Service Bulletin No: 57-017

Modification No: EC-11-0355

WINGS - GENERAL**REPLACEMENT OF THE LEFT AND RIGHT AILERON OUTBOARD BEARING-BRACKETS****1. Planning Information****A. Effectivity**

Replacement of the Bracket Assembly
Figure 3

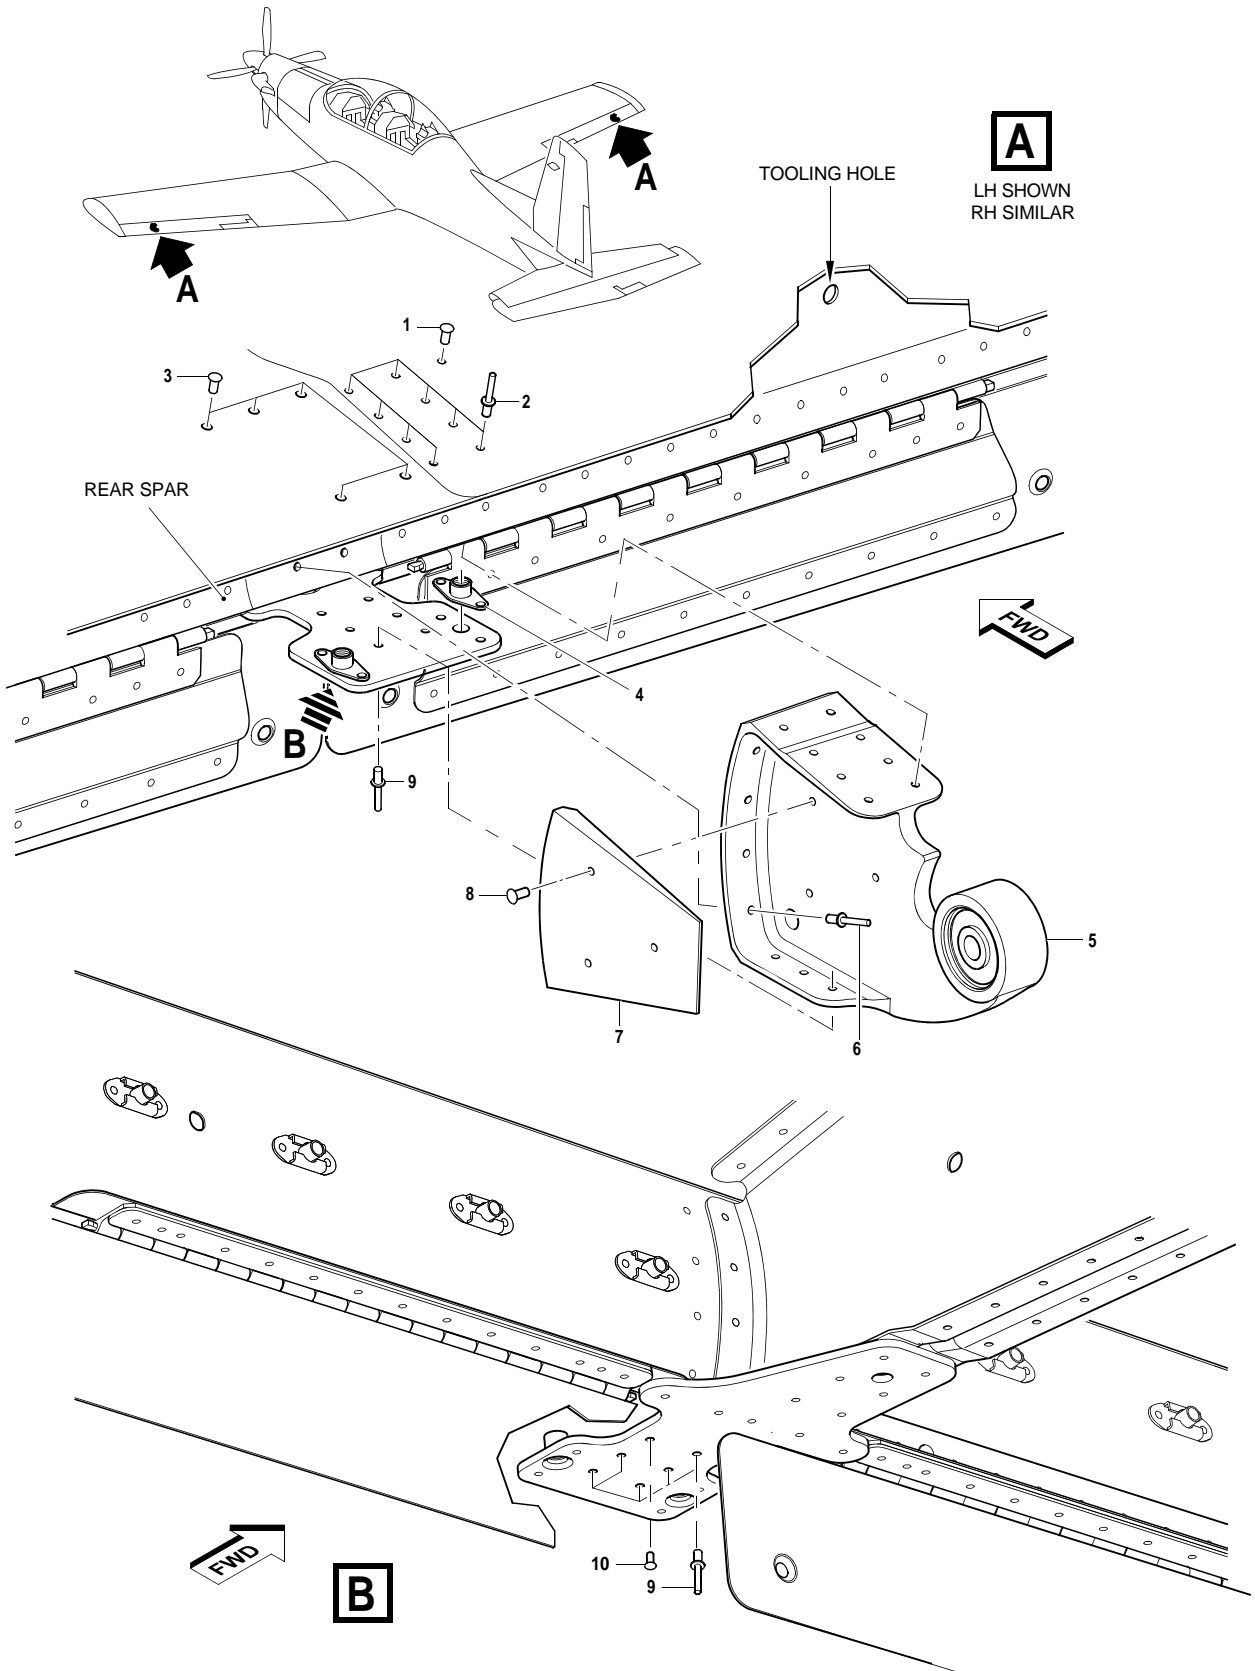
E. Prepare the Drilling Sheet (Ref. Fig. 3)

- (1) Put the drilling sheet (P/N 513.57.09.153, LH or P/N 513.57.09.154, RH) against the old bracket.
- (2) Use a 3.2 mm diameter drill and drill the six holes in the drilling sheet (P/N 513.57.09.153, LH or P/N 513.57.09.154, RH). Do this through the holes in the lower flange of the old bracket.

- (4) Make sure the drilling sheet (P/N 513.57.09.153, LH or P/N 513.57.09.154, RH) is firmly against the wing rear-spar flange of the old bracket.
- (5) Use a 3.2 mm diameter drill and drill the eight holes in the drilling sheet (P/N 513.57.09.153, LH or P/N 513.57.09.154, RH). Do this through the holes in the wing rear-spar flange of the old bracket.

- (1) Put the drilling sheet (P/N 513.57.09.153, LH or P/N 513.57.09.154, RH) (that you prepared in Step 3.E) in position on the new bracket.
- (2) Install gripper pins, or equivalent, in the six holes on the lower flange and in the two holes on the upper flange.
- (3) Use a 3.2 mm diameter drill and drill the eight holes that attach the flange of the new bracket to the rear wing spar. Do this through the holes in the drilling sheet.
- (4) Remove the drilling sheet from the new bracket.

Removal / Installation of the Shim and Bracket
Figure 1

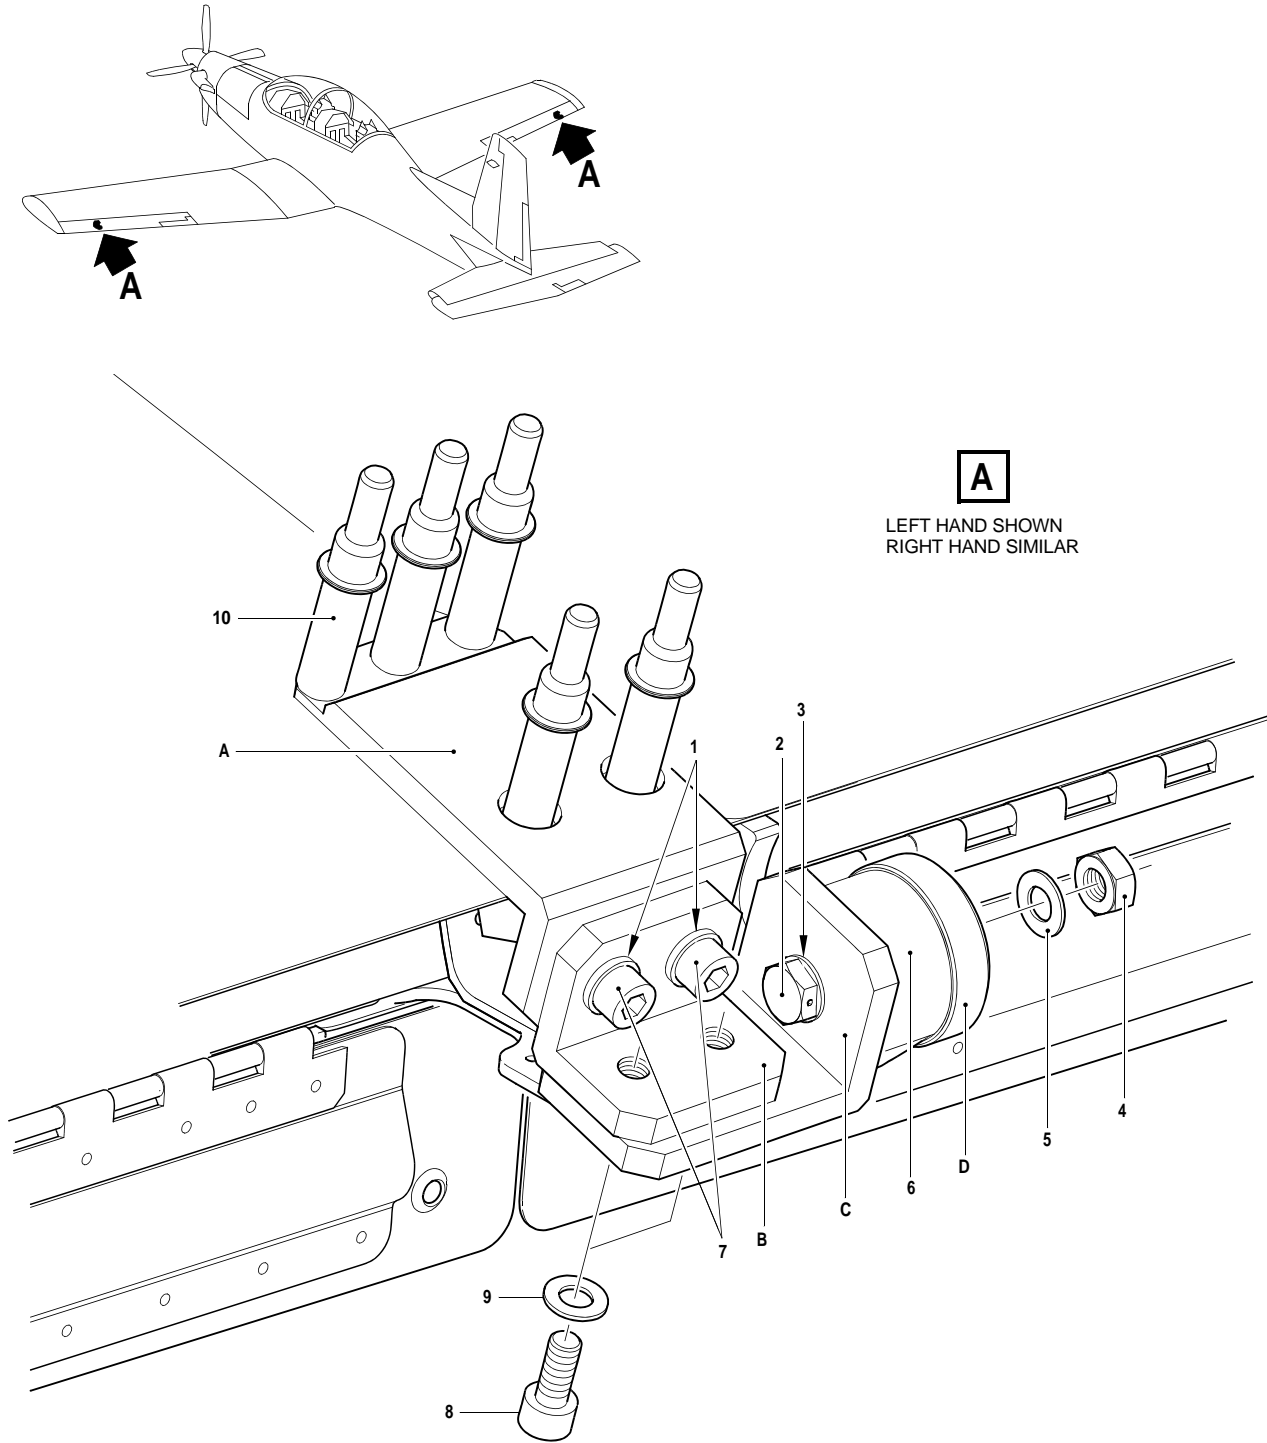
A Operator has found cracks in the aileron outboard bearing-bracket (bracket), P/N 557.22.09.281 (LH) and P/N 557.22.09.282 (RH) installed on some of his aircraft. If the rivets in the affected location come out, they could cause the aileron to become jammed or lost in flight.

It is possible for stress corrosion cracks to occur in the bracket, P/N 557.22.09.281 (LH) and P/N 557.22.09.282 (RH) made of aluminum alloy 2024-T351. These cracks would occur in the areas around the attachment fasteners.

Initially the material specification of the brackets, P/N 557.22.09.281 (LH) and P/N 557.22.09.282 (RH) was aluminum alloy 2024-T351. The material specification was subsequently changed to aluminum alloy 2124-T851 to reduce the risk of damage from stress corrosion. The part number was not changed when the new material specification was introduced.

This Service Bulletin is issued to replace the left and right brackets if they are not made from aluminum alloy 2124-T851.

- (1) If installed, make a note of the position of the shim (7) on the applicable bracket (5).
- (2) If installed, use the applicable sized drill and remove the three rivets (8) that attach the shim (7) to the applicable bracket (5).
- (3) Remove and keep the shim (7).
- (4) Remove the five rivets (3) from the top skin, outboard of the bracket (5).

- (1) Measure and record the height of the tail of the inboard forward rivet (10) that attaches the flange of the bracket (5) to the lower skin.
- (2) Remove the six rivets (9 and 10) that attach the flange of the bracket (5) to the lower skin.
- (3) Remove the eight rivets (2) that attach the flange of the bracket (5) to the upper skin.
- (4) Remove the rivet (1) from the upper skin.

- (1) Put the shim (7) in the same position on the new bracket (5) (P/N 557.22.09.547, LH or P/N 557.22.09.548, RH) as noted in Step 3.B.(1).
- (2) Use a 2.4 mm diameter drill and drill the three holes that attach the shim (7) to the new bracket (5) (P/N 557.22.09.547, LH or P/N 557.22.09.548, RH). Do this through the holes in the shim (7).
- (3) Countersink the inboard holes in the new bracket (5) (P/N 557.22.09.547, LH or P/N 557.22.09.548, RH).
- (4) Remove the shim (7).

- (12) Install the rivet (Fig. 1, Item 10) (P/N MS20426AD4) in the forward inboard hole in the location shown.
- (13) Make sure the tail of the rivet (Fig. 1, Item 10) (P/N MS20426AD4) is the same dimension as recorded at Step 3.D.(1). The minimum height is 0.5 mm. If necessary, remove material from the tail.
- (14) Install the remaining rivets (Fig. 1, Item 9) (P/N CR3222-4) in the other five positions.

Installation of the Placing Device
Figure 2

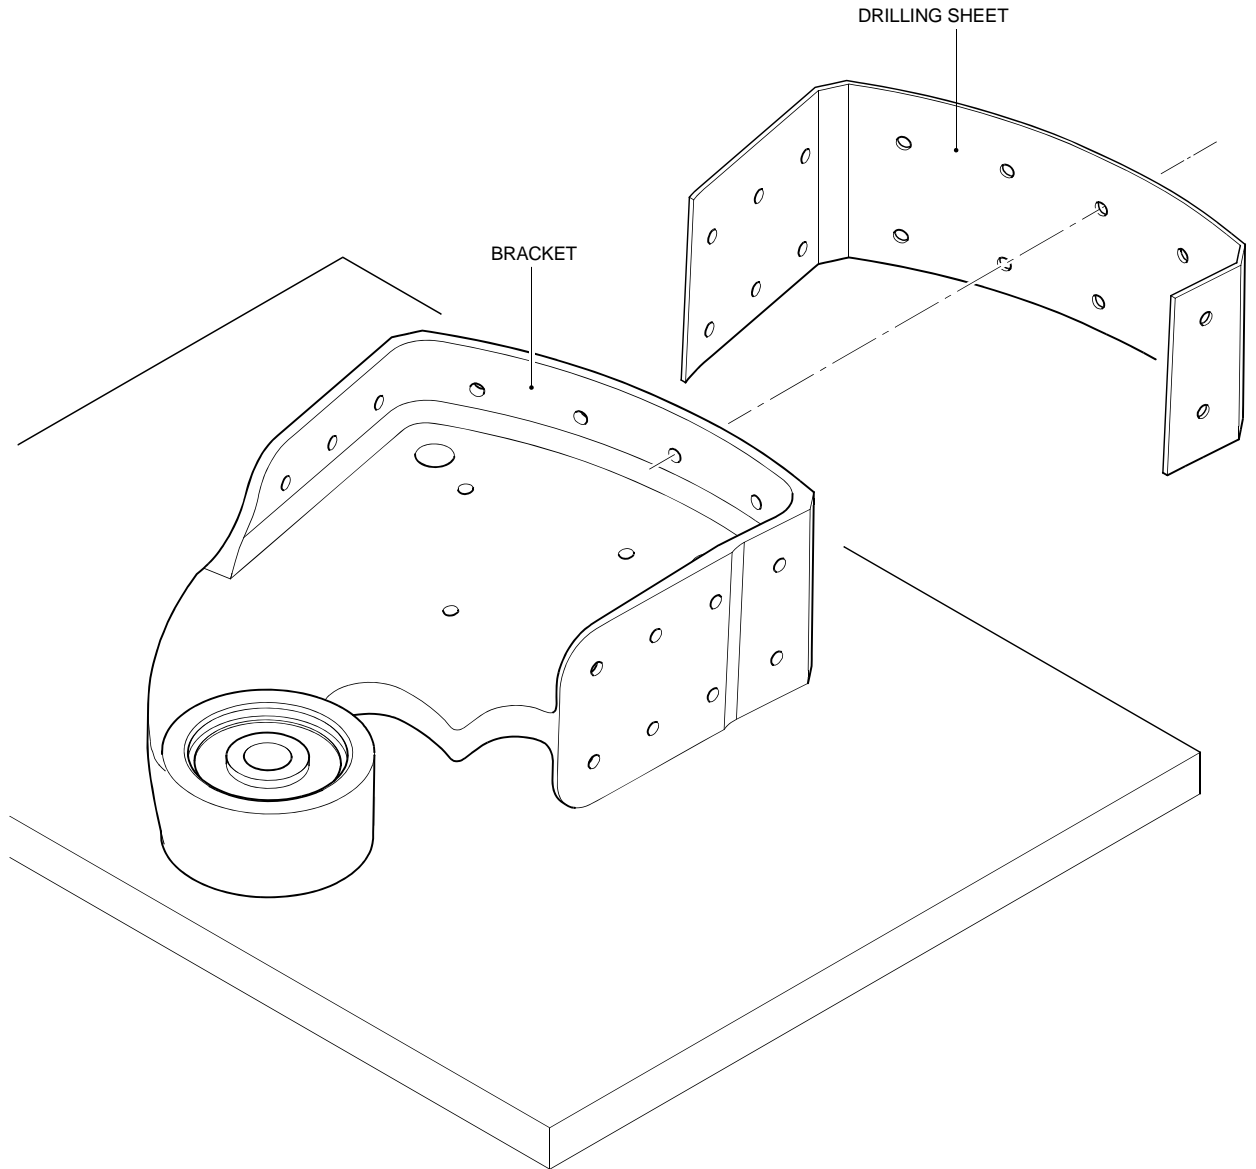
C. Install the Placing Device (Ref. Fig. 2)

- (1) Make sure there are no pencil marks on all parts of the placing device. If necessary, remove them with the absorbent paper (Material No. P02-031) made moist with the solvent (Material No. P01-010).
- (2) Put part A of the placing device in position on the top skin.
- (3) Hold in position with gripper pins, or equivalent, (10) through the five rivet holes in the top skin.

- (4) Put part C in position against the bearing of the bracket (6). Make sure the mating face of the bracket is smooth. If necessary, remove the paint.
- (5) Install the bolt (2), the washer (3), part D of the placing device, the washer (5) and the nut (4). Do not tighten the nut (4).
- (6) Put part B of the placing device in position against part A and part C of the placing device.
- (7) Install the two screws (7) and the washers (1).
- (8) Install the two screws (8) and the washers (9).
- (9) Make sure the gripper pins, or equivalent, (10), the screws (7 and 8) are tight.
- (10) Make sure that:
 - The bolt (2) and the spherical bearing can move freely
 - Part C of the placing device is in complete contact with the bracket (6).

- (11) Tighten the nut (4).
- (12) Draw lines around part A of the placing device to show its position on the wing top skin.
- (13) Draw lines around part B of the placing device to show its position against part A.
- (14) Draw lines around part B of the placing device to show its position against part C.

- (1) Put the new bracket (6) (P/N 557.22.09.547, LH or P/N 557.22.09.548, RH) in position on the wing.
- (2) Put the washer (3) on the bolt (2).
- (3) Put the bolt (2) through part C of the placing device and new bracket (6) (P/N 557.22.09.547, LH or P/N 557.22.09.548, RH).
- (4) Put the spherical bearing (that you kept in Step 3.D.(8)) in the new bracket (6) (P/N 557.22.09.547, LH or P/N 557.22.09.548, RH) and on the bolt (2).
- (5) Install part D of the placing device, the washer (5) and the nut (4).
- (6) Make sure that the new bracket (6) (P/N 557.22.09.547, LH or P/N 557.22.09.548, RH) is firmly against the wing rear-spar web.
